# VALUE ENGINEERING REPORT

SR 42 Widening  
Clayton County  
PI Nos.: 720815 / 720817  
Project Nos. STP-037-2(54) / BHF-037-2(55)  
March 19, 2008

Georgia Department of Transportation  
No.2 Capitol Square  
Atlanta, GA 30334  
(404.651.7468)

MACTEC Engineering and Consulting, Inc.  
3200 Town Point Drive NW, Suite 100  
Kennesaw, GA 30144  
(770.421.3346)

ITEM N<sup>o</sup>: A-1  
CLIENT: GDOT  
Sheet 2 of 4

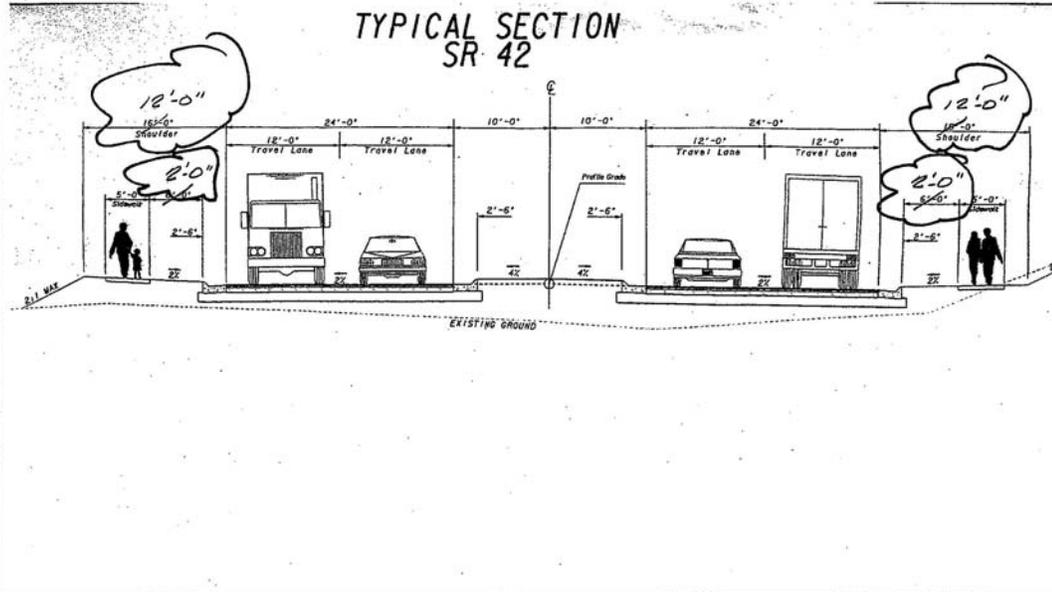
The original concept calls for 16 foot urban shoulders.

Revise the shoulder width to 12 feet. See proposed sketch on page 2 of 4.

Reducing the shoulder width by 4 feet on each side of the roadway will reduce the amount of earthwork required for the project and will reduce the amount of required right of way.

ITEM N<sup>o</sup>: A-2  
CLIENT: GDOT  
Sheet 2 of 5

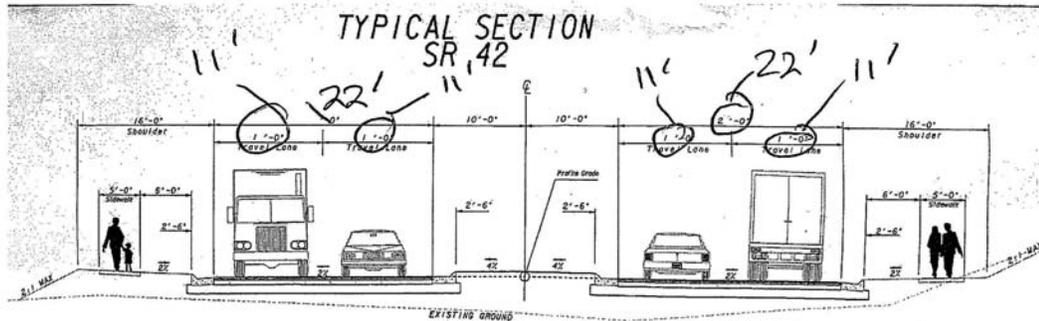
The original concept included 4-12 foot travel lanes for the typical section.

Use 4-11 foot travel lanes.

The proposed roadway is designed as an urban section at a design speed of 45 mph. Using an urban section and a design speed of 45 mph, the 11 foot lanes should function similar to the 12 foot lane width. There is also a 2 foot gutter adjacent to each lane giving additional area before the curb.

ITEM N<sup>o</sup>: A-2.1  
CLIENT: GDOT  
Sheet 2 of 4

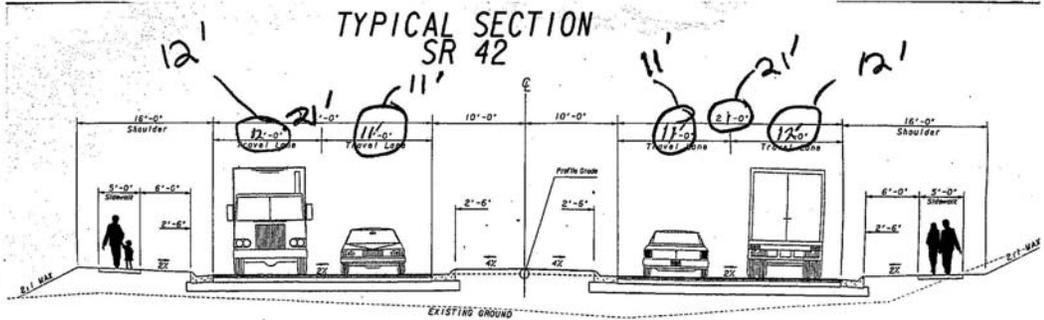
The original concept calls for 4-12 foot travel lanes.

Change the inside lane width from 12 feet to 11 feet, keeping the outside lanes at 12 feet.

With a 45 mph speed design and in an urban section, 11 foot lanes should function similar to 12 foot lanes. Due to the truck percentage of 15% on this route, retaining the outside lanes at 12 feet will help facilitate the truck traffic.

JOB NO. A-3 SHEET 2 OF 4  
PHASE \_\_\_\_\_ TASK \_\_\_\_\_  
JOB NAME \_\_\_\_\_  
BY AW DATE 2/28/08  
CHECKED BY DCW DATE 2/28/08

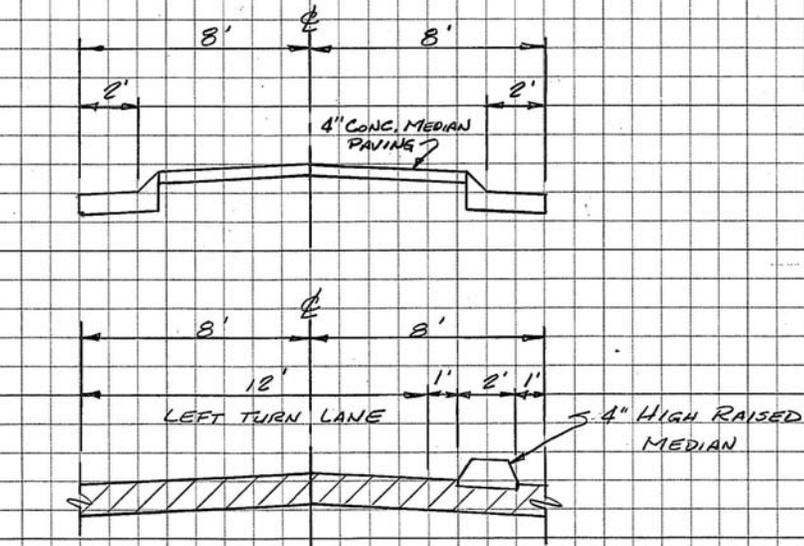
The original concept calls for a 20 foot raised median with a 2.5 foot curb and gutter. Left turn bays reduce the median to 8 feet with a 2.5 foot curb and gutter.

Reduce the median to a 16 foot raised median with 2.5 foot curb and gutter. At left turn lanes, reduce the median to a 2 foot raised median without concrete gutters and offset the raised median 1 foot from the edge of the travel way. See attached sketch page 2 of 4.

Reducing the median width would reduce the amount of new right of way, reduce the amount of earthwork and reduce the amount of median pavement. Maintaining a 2 foot raised concrete median at the left turns would present a clear visual and physical barrier.

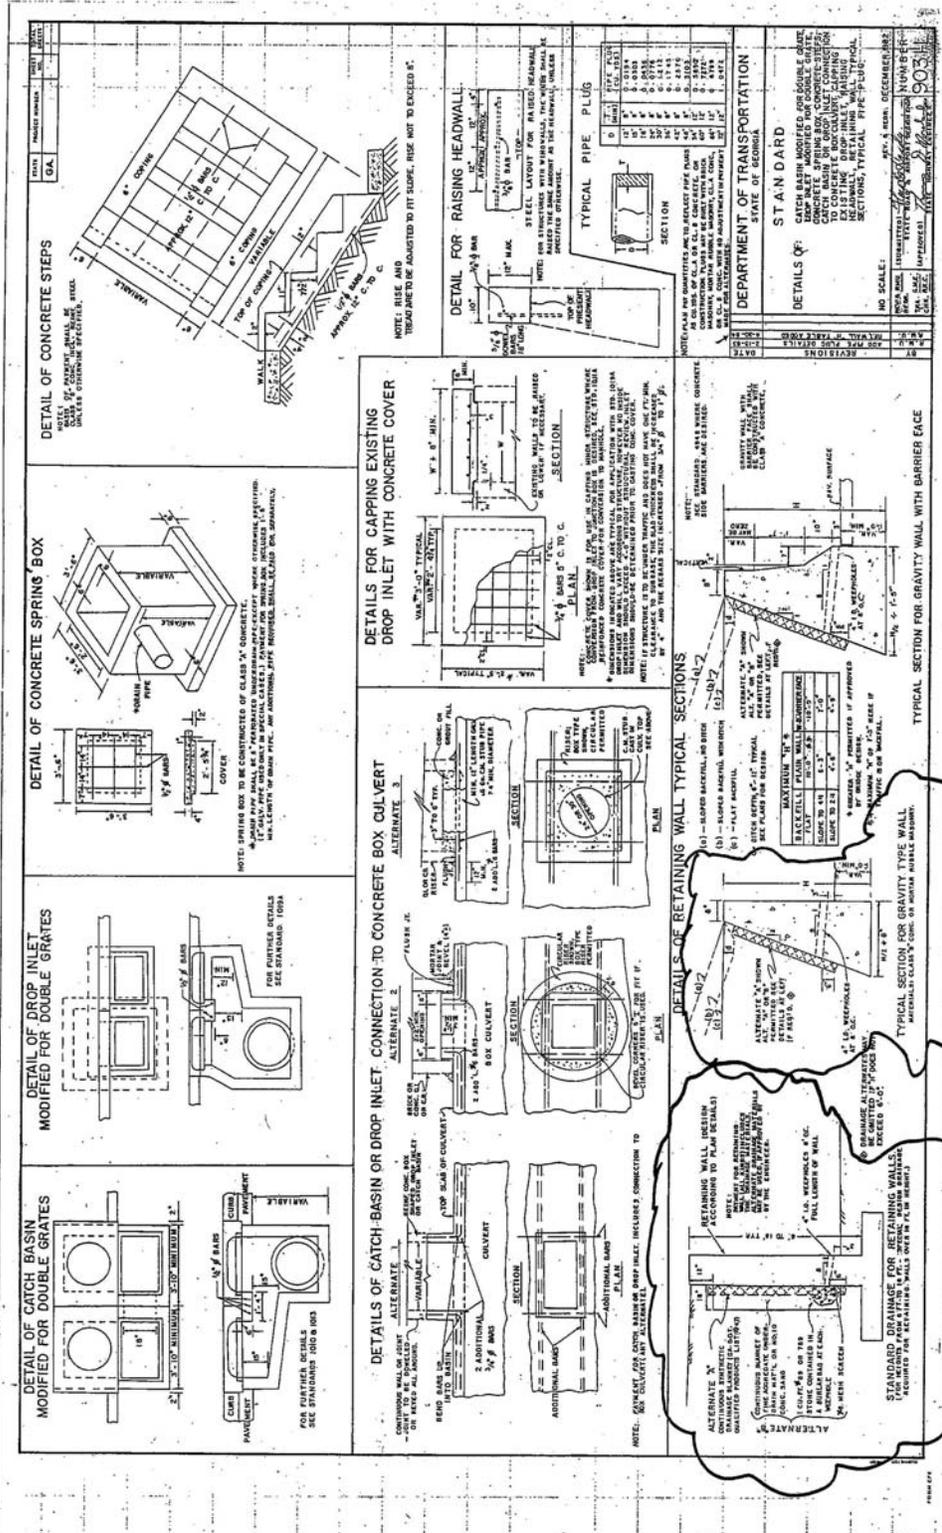
The original cost estimate is based on constructing the retaining walls utilizing reinforced concrete.

Based on the review of cross sections, the average height of the walls is approximately 7 ft. Utilizing gravity walls (GA Std. 9031L) will work for 75% of the locations.

ITEM N<sup>o</sup>: H1  
CLIENT: GDOT  
Sheet 2 of 7

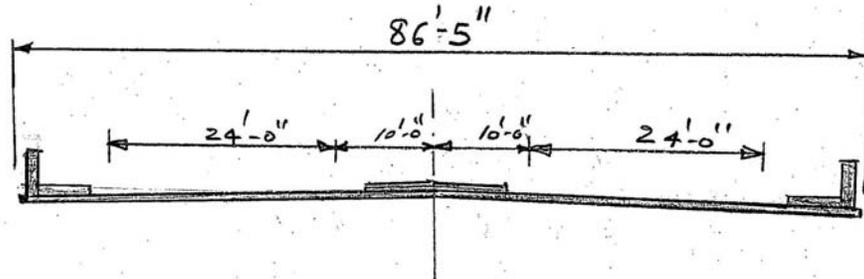
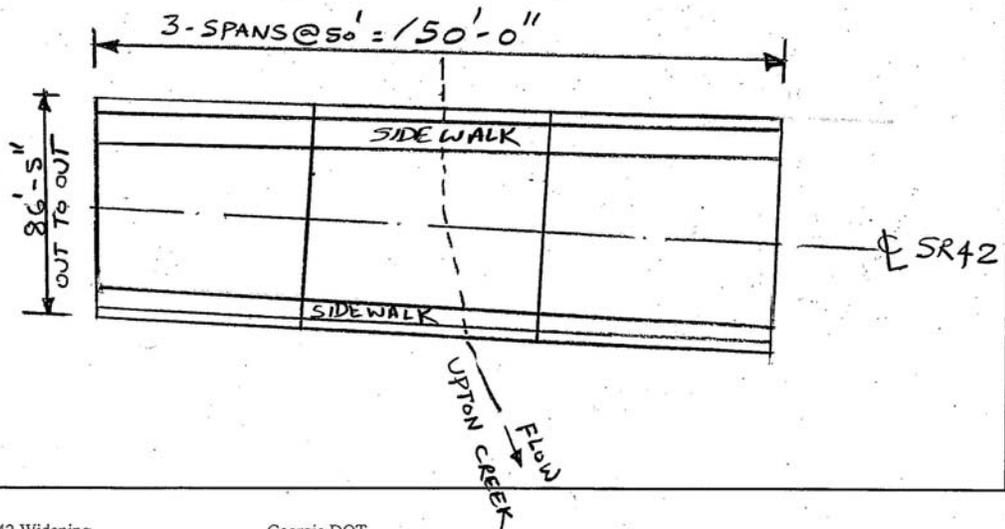
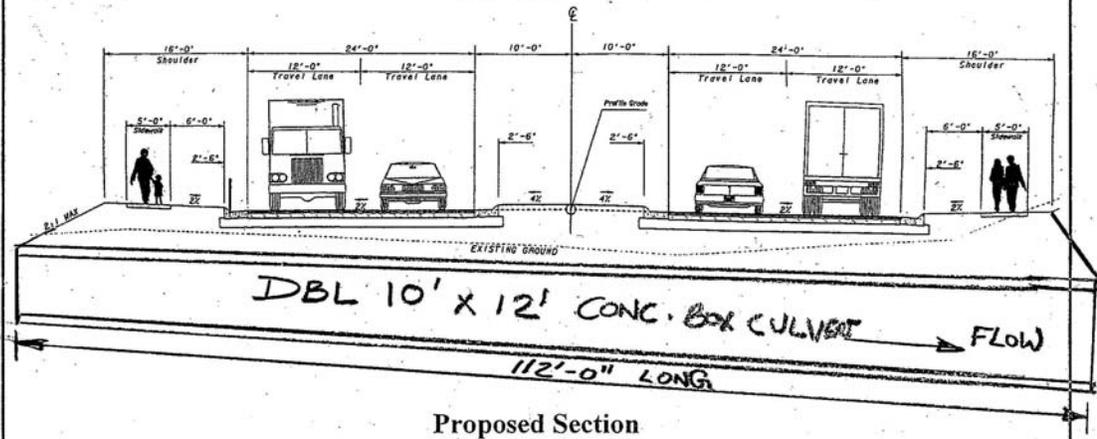
The original concept allowed for 150 feet long  $\times$  86.5 feet wide bridge at this stream crossing dependant on the outcome of a hydraulic study. This suggestion is to use double 10 ft  $\times$  12 ft  $\times$  112 ft box culverts since they are more economical.
